Errata to the Public Draft

2012 Central Valley Flood Protection Plan and Volume I, Attachments 1 - 6

Errata to the Public Draft 2012 Central Valley Flood Protection Plan

Figure 5-1. Vegetation Management for Existing Levees – Long Waterside Slope and Landside Berm

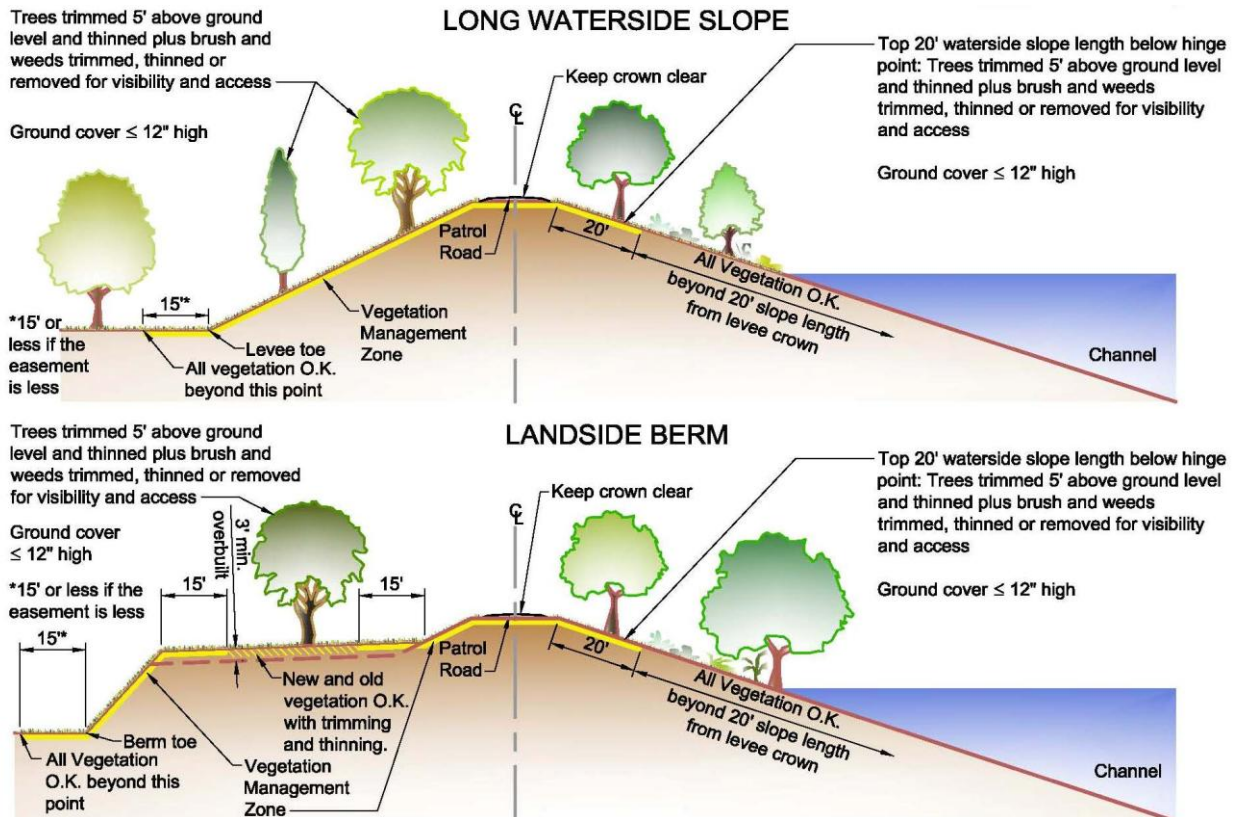
15. Attachment 2 - Section 5.4.3, page 5-13

Replace Figures 5-1 through 5-2 with the following:

Trees and other woody vegetation may be: (1) planted, and (2) allowed to naturally revegetate on a landside planting berm. Only the portion of the landside planting berm that is both 15 feet or more from the landside levee slope and 15 feet or more from the landward top of the planting berm may be planted and allowed to naturally revegetate. All trees and other woody vegetation in this area of the planting berm must be trimmed up 5 feet above the ground and thinned for visibility. Any landside berm can be a planting berm if its top is more than 30 feet wide (as measured perpendicular to the levee centerline) and the berm is at least 3 feet thicker than required for levee integrity (to account for potential overturning of trees from windthrow) (see Figure 5-1).

Trees and other woody vegetation may be planted on a waterside planting berm below the vegetation management zone, and on natural ground more than 20 feet (slope distance) waterward of the waterside levee crown hinge point.

Figure 1-1 “Flowchart for Making Findings Related to Urban Level of Flood Protection” is replaced by the version on the following page:

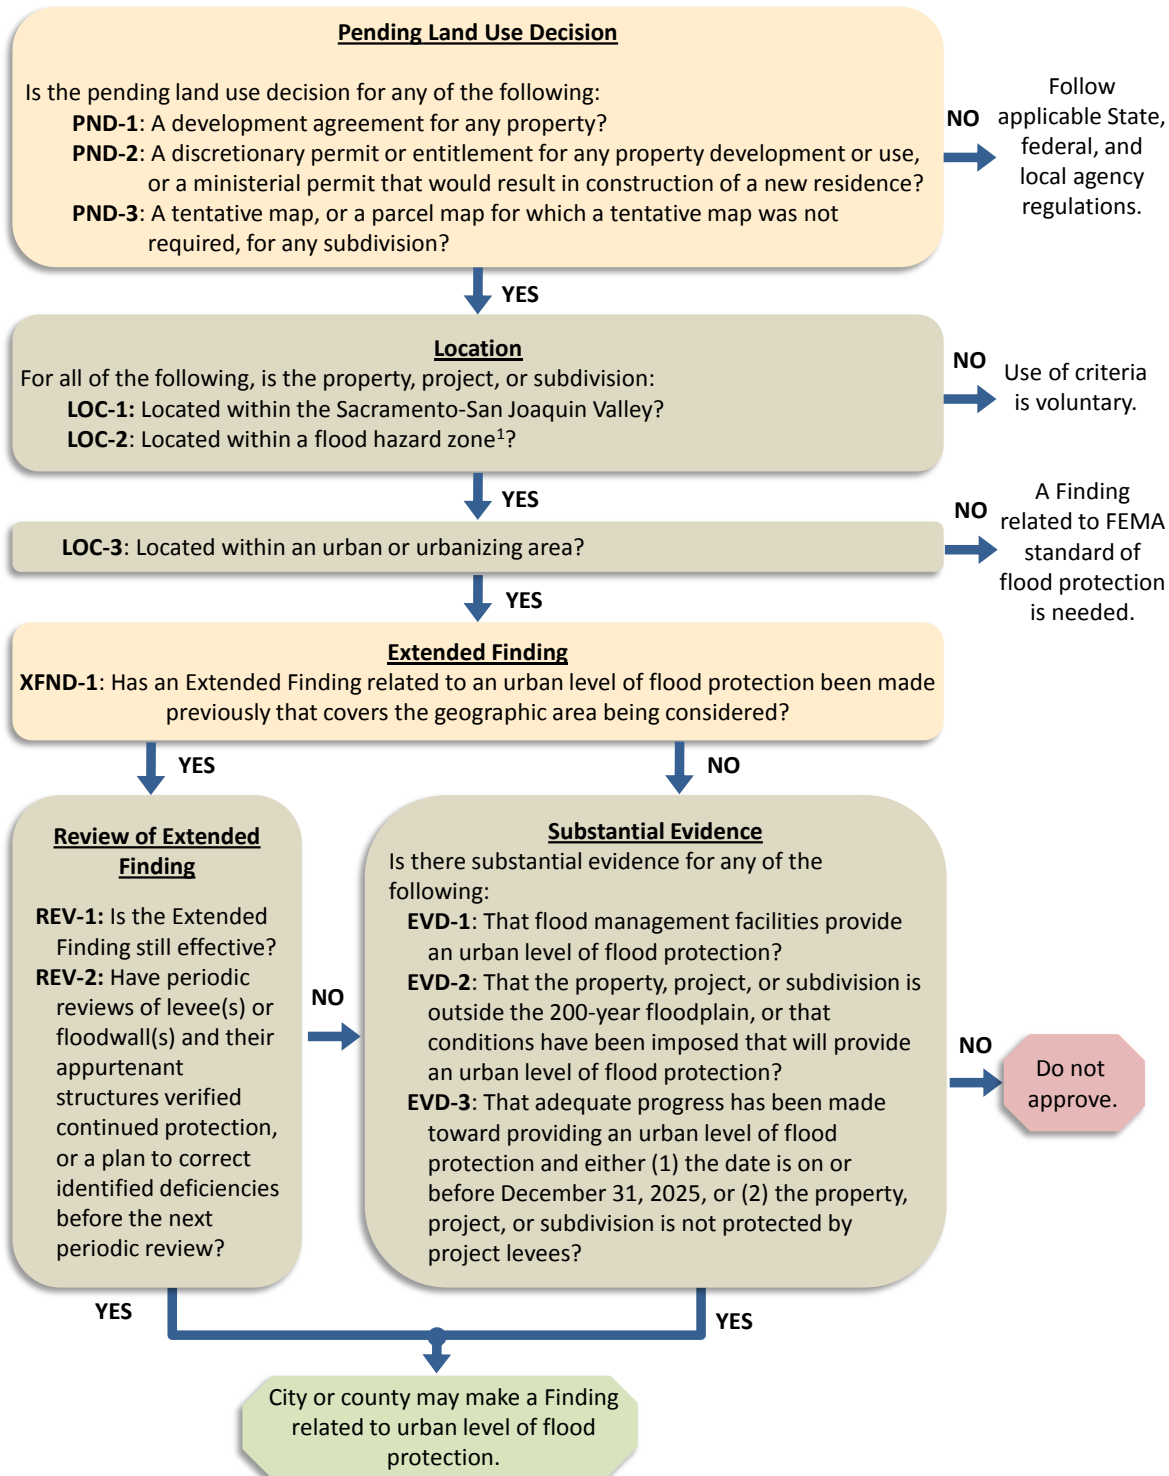
21. Attachment 3 – Documents Incorporated by Reference, Figure 1-1, page 1-11
